# CITY PLANNING COMMISSION

- APPLICATION:**
- A. Special Permit to construct a 96 seat drive through restaurant on 0.74 developed acres in the General Commercial (C-2) zone.
  - B. Lot line adjustment to merge 5 developed lots totaling 0.74+ acres

**LOCATION:** 2601 and 2615 Broadway

**PROPOSAL:** The applicant is requesting the necessary entitlements to construct a Long John Silver's drive through seafood restaurant and merge 5 parcels into one parcel.

**STAFF MODIFIED SITE PLAN**

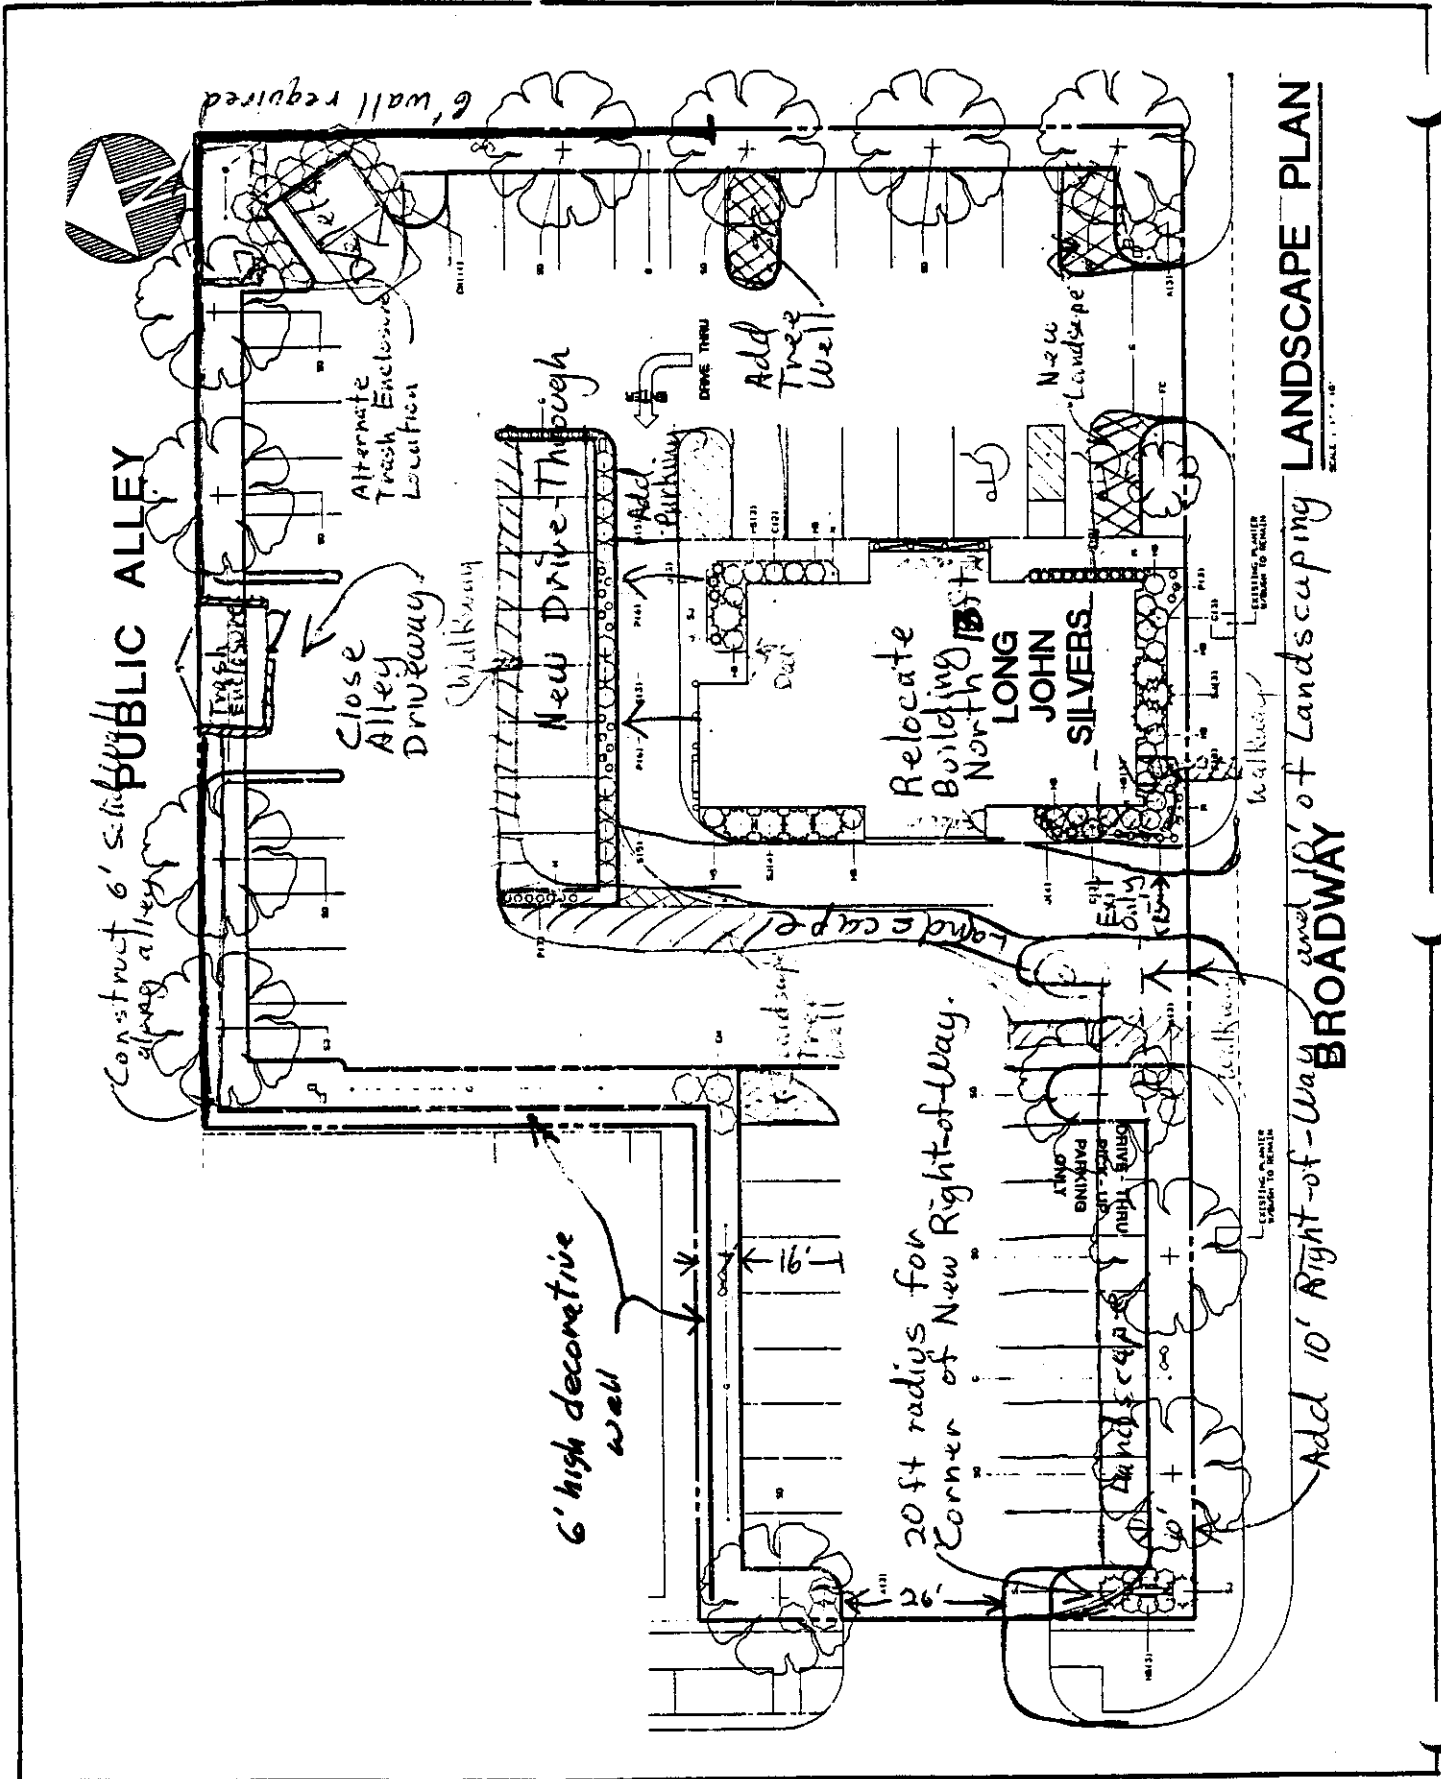
Staff recommends that no access be allowed off the alley due to the location of residential uses to the north of the subject site. Staff recommends relocation of the trash enclosure so that the dumpster unit can be accessible from both the alley for pick up and restaurant for disposal of garbage. The landscape stripe should be continued along the north property line, adjacent to the wall as shown in Exhibit A, Staff Modified Site Plan. The trash enclosure shall comply with the Trash Enclosure Guidelines, Exhibit D.

The applicant proposes the drive through to be located adjacent to a two way entry exit on Broadway. Staff is concerned over the lack of distance between the drive through exit and oncoming traffic off Broadway. Staff recommends that the Broadway driveway be modified as shown on Exhibit C. The City Traffic Engineer recommends a one-way exit only traffic from the drive-up window as shown in Exhibit C. The width of the driveway shall be 15 feet. This requires closure of the middle 35 foot wide driveway and reducing the drive-up window lane to an exit only 15 foot wide lane. An "exit only" sign should be installed at this location.

The Traffic Engineer noted that the driveway off 26th Street should be moved northward 10 feet to allow for the additional 10 feet of right-of-way required along Broadway. Staff recommends the revised site plan reflect the driveway location revision (See Exhibit C).

In relocating the building, staff recommends deletion of the row of parking stalls located north of the drive through line on the north side of the building and retain a 5 foot wide landscape strip along the drive through aisle. Deletion of 8 spaces does not affect the required parking total. Refer to Exhibit C for Staff Modified Site Plan.

Staff recommends that the trash enclosure be designed with alley access for disposal trucks and employee access of the restaurant site. Residential refuse is picked up from the alley, thereby reducing the need for garbage trucks entering the site. Two locations are suggested (see Exhibit C).

Staff has noted that additional pedestrian walkways would be appropriate as shown on Exhibit C. A walkway should be constructed opposite the trash enclosure on the north side of the building across the 6 foot landscape strip.

A second walkway is proposed to the west of the drive through exit onto Broadway. This walkway would provide access for pedestrians from the parking lot to the sidewalk and to the front of the restaurant without directly affecting the drive-up window traffic.

A third walkway is recommended from the front of the building to the sidewalk.

2. Six foot high decorative walls shall be shown on a revised site plan adjacent to residential uses and the alley as per Exhibit C.
3. The drive through driveway shall be redesigned into a one way only exit onto Broadway as shown on Exhibit C. This driveway onto Broadway shall be reduced to 15 feet in width.

4. The 26th Street driveway shall be relocated northward approximately 10 feet and designed to City standards.
5. The applicant shall dedicate an additional 10 feet of right-of-way along Broadway. The restaurant shall be relocated 13 feet to the north so that a 10 foot landscape area will exist between the new Broadway right-of-way and the building face. The site plan shall be reviewed and approved by the Planning Director prior to issuance of building permits.

7. The trash enclosure shall be relocated to provide alley access and restaurant access. The enclosure shall be designed according to the attached trash enclosure guidelines (Exhibit D).

12. Additional walkways shall be included on the revised site plan as noted on Exhibit C, unless modified by the Design Review Board.
13. Bicycle parking shall be provided as per the City Parking Ordinance.

**ELEVATIONS**

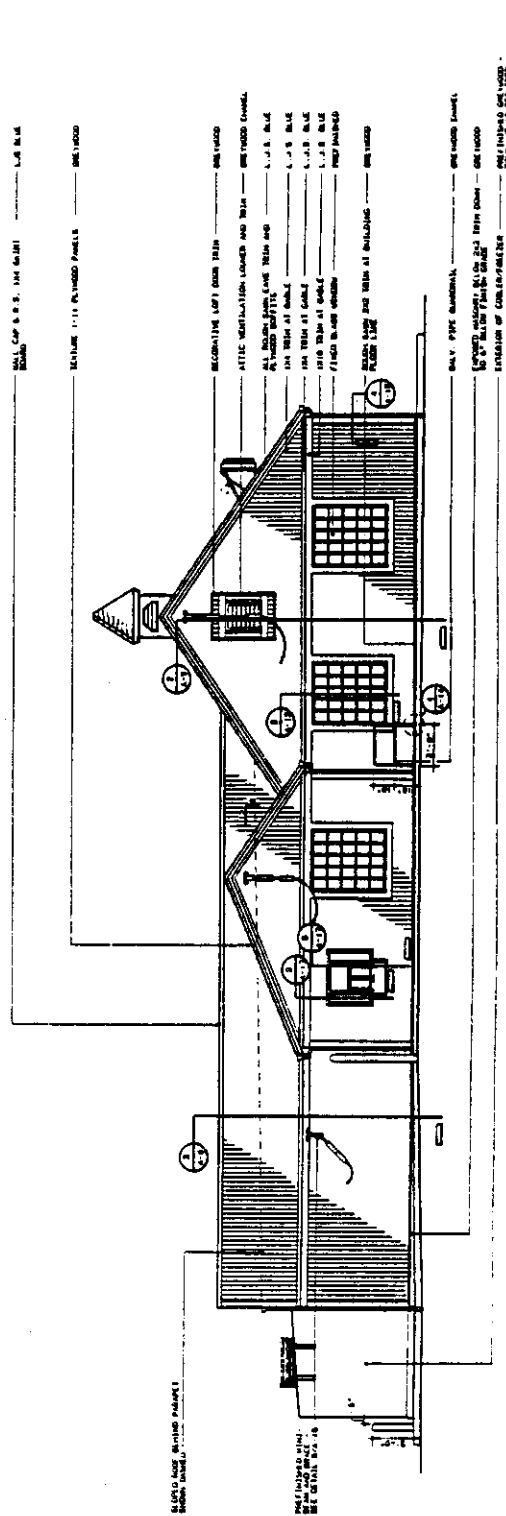
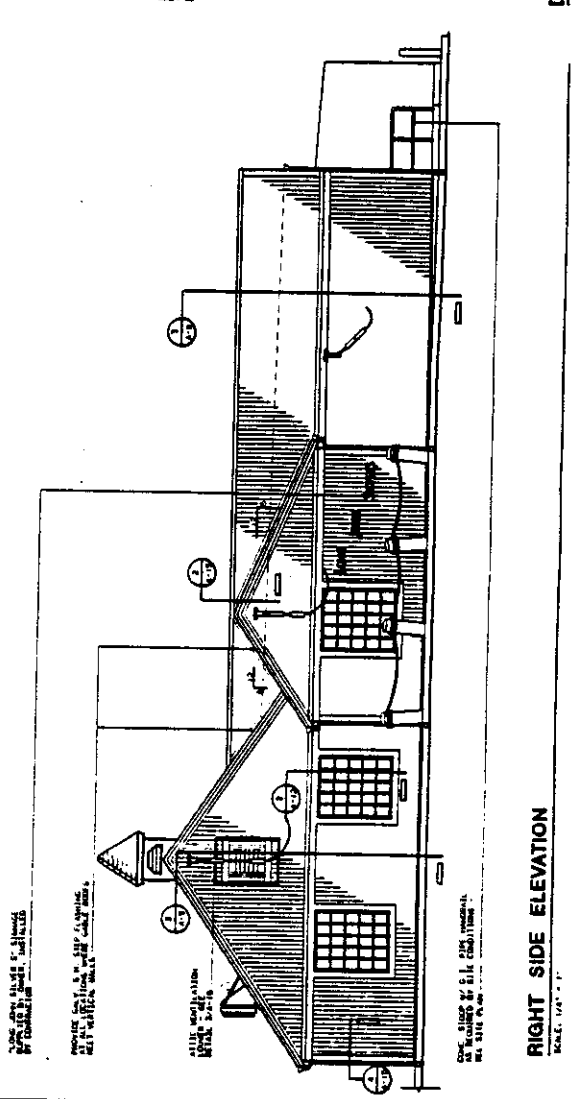
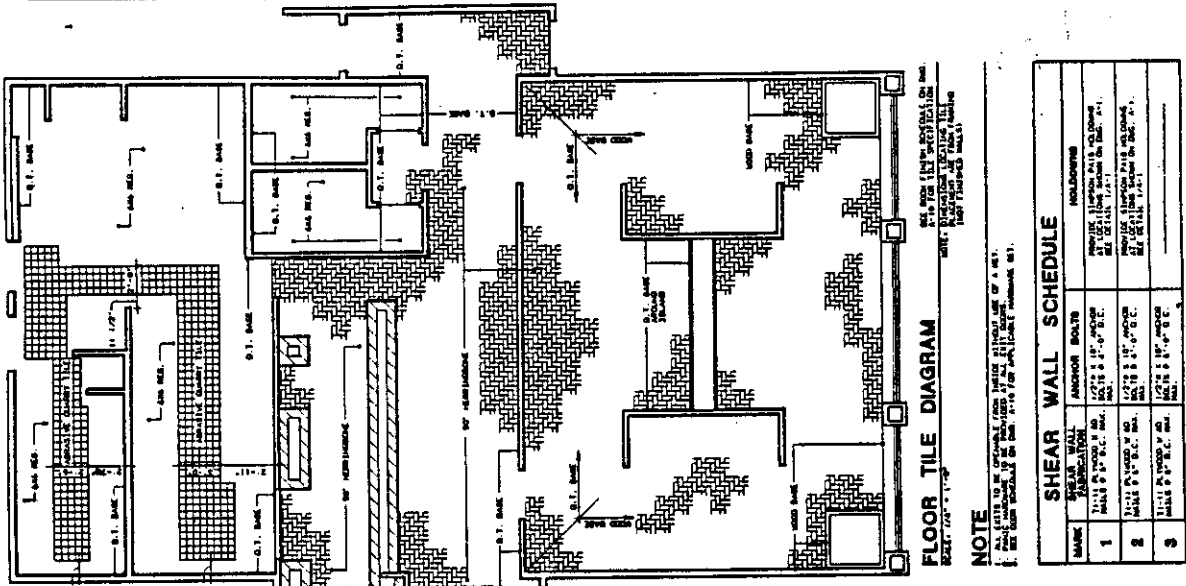
Staff notes that the architecture is standard for the building used throughout the nation. Staff has noted that earth tone browns may be more acceptable a color due to the colors of newer buildings and restaurants along Broadway. Staff field observed the Long John Silver's in Placerville as being painted brown with dark brown trim and recommended the brown color scheme rather than the blue and blue-gray colored proposed.

The applicant has shown attached building identification signage on the elevations. Staff recommends the use of a monument type sign if a detached sign is requested. The overall height of the sign should not exceed 12 feet above the adjacent Broadway sidewalk surface. Staff recommends the review and approval by the Planning Director of a uniform sign program prior to issuance of sign permits.

8. The applicant shall revise the walkway across the drive through window aisle to the satisfaction of the Design Review Board. Architectural modifications, including use of brown earth tones, are to be established by the Design Review Board and approved by staff prior to building permit issuance.
